**CASE COVER SHEET**

City of Rockwall  
Planning and Zoning Department  
385 S. Goliad Street  
Rockwall, Texas 75087

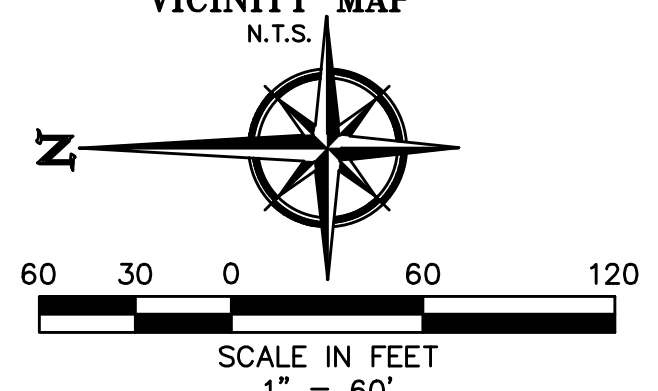
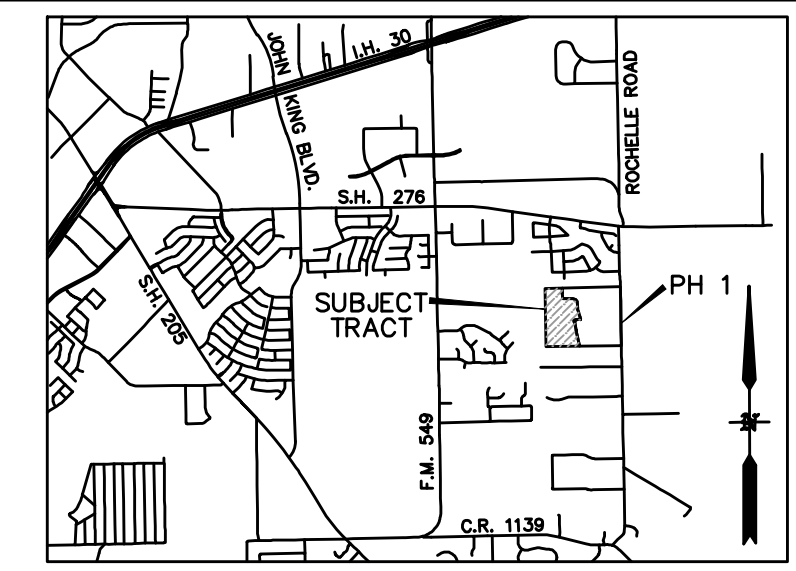
**PARKS COMMENTS:**
